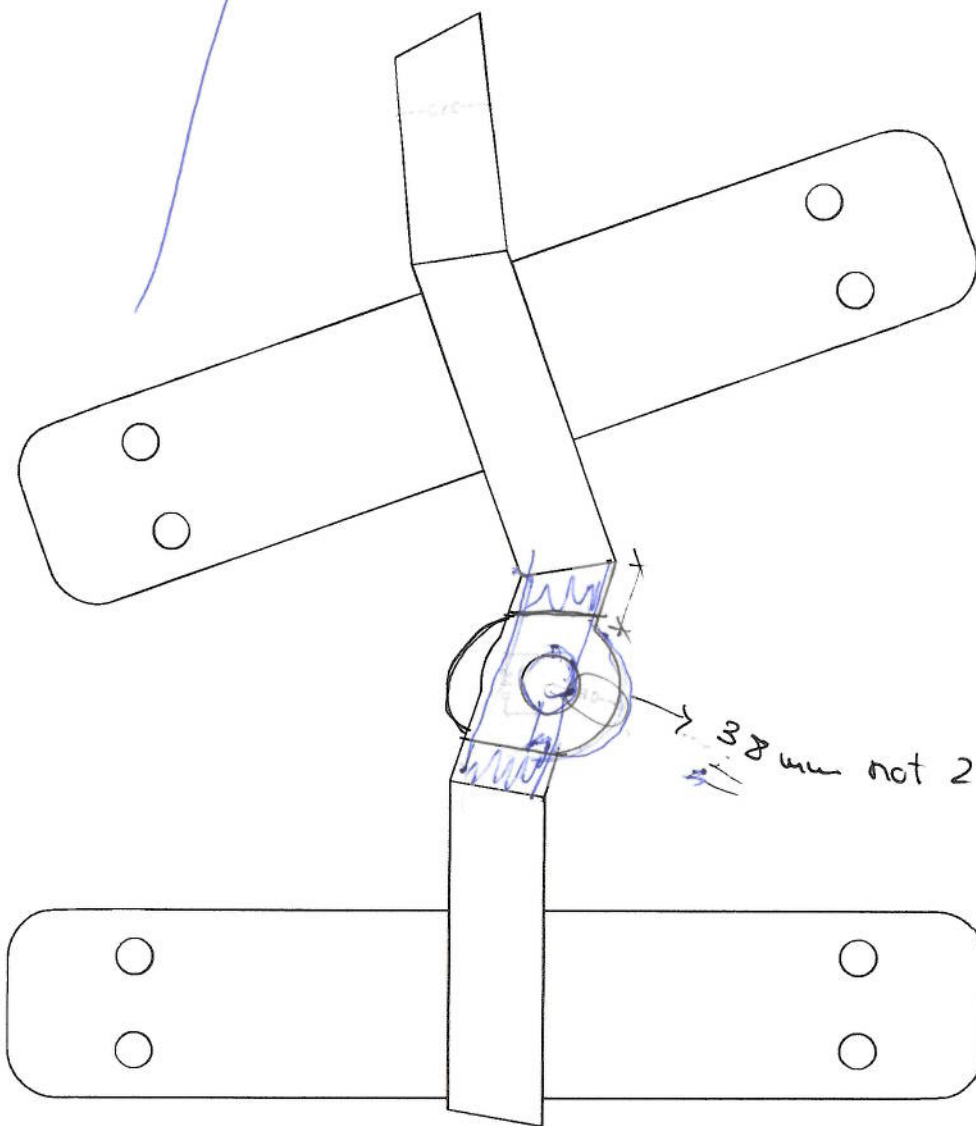
22mm belt

16mm → 15.9mm

22mm

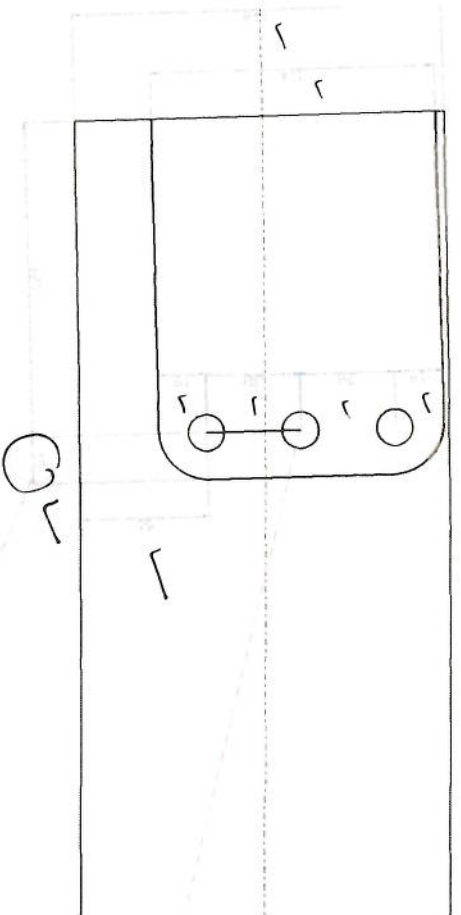
17.9mm

On page 1 in the document you sent us, there is a dimension of 88mm (located in the bottom center of the page). To what does it refer? → ??

Bolt diameters = 14.7mm (12.7mm bolt size + 2mm)
 Hole diameter = 14.9mm
 Bolt " = 12.7mm

oversizing of hole

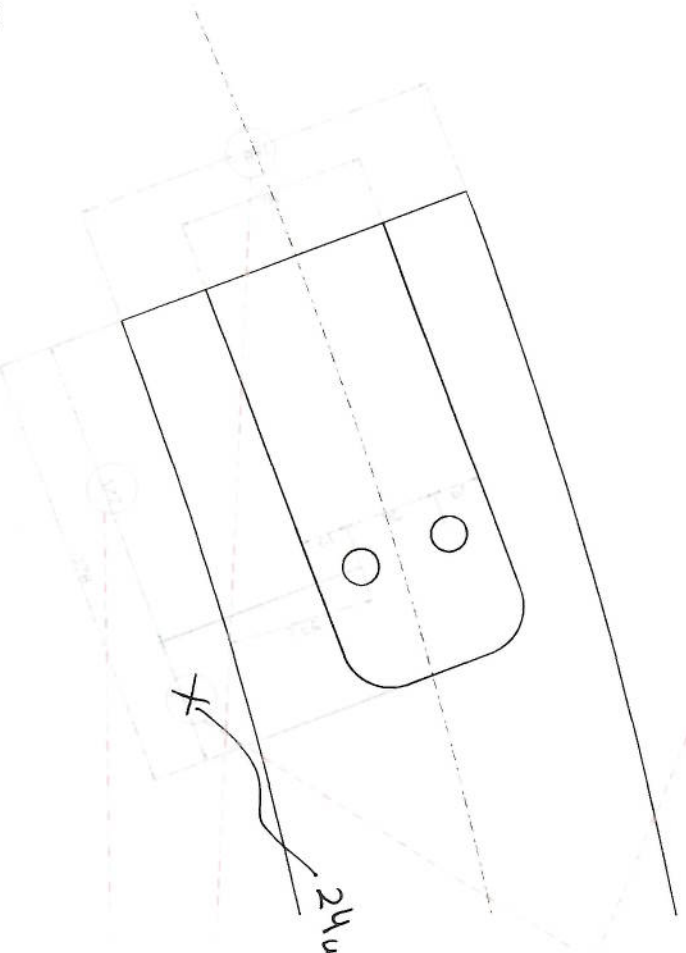
Are these dimensions correct? 19mm & 24mm

The ribs are currently scripted at a constant width of 148mm. Preferably, we would like it to remain as such instead of varying the width. Is this possible or would dead weight be an issue?

This dimension seems quite large, is there any way to reduce it?
 No, it is too due with failing of the plywood due to shear in the bolts in reality there is no need for the plate to be as long but the bolts need to be 7x dia from the center of bolt.

NO →

OK. For 148mm constant
